MEMORANDUM

From:	Catherine Brimble Senior Landscape Officer		
Service	SDL Landscape and Trees	App No:	250931
Address:	Finchwood Park, Sheerlands Road, Arborfield, Wokingham, RG40 4QY.		
Proposal:	Application for approval of Reserved Matters pursuant to Outline Planning Consent O/2014/2179 (as varied by 181194, dated 14/11/2018). The Reserved Matters comprise details of 161 dwellings within parcels P11, P12a & P12b together with associated internal access roads, parking, landscaping, footpaths and sustainable urban drainage systems (SuDS). Details of access, appearance, landscaping, layout and scale to be considered.		
Type of Development:	Major Dwellings (10+)		
Site Visit Made:	Yes/No

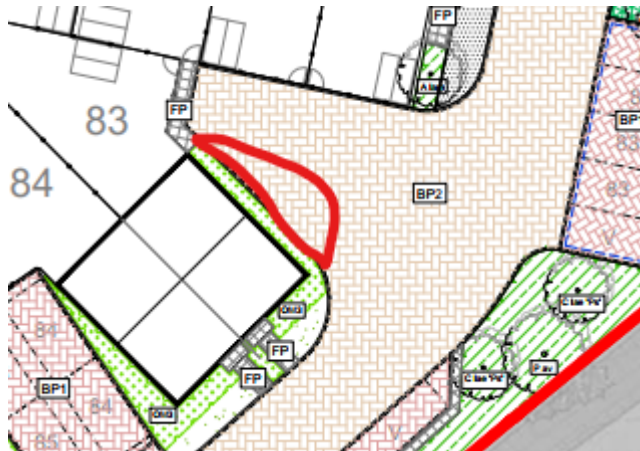
4. The turning head between plots 82 & 83 is excessively wide to the front of this area. I suggest the hardstanding is reduced by the red line in the extract below to enable more planting in this location. I have checked the vehicle tracking and this area seems to be outside what is required for refuse vehicles.
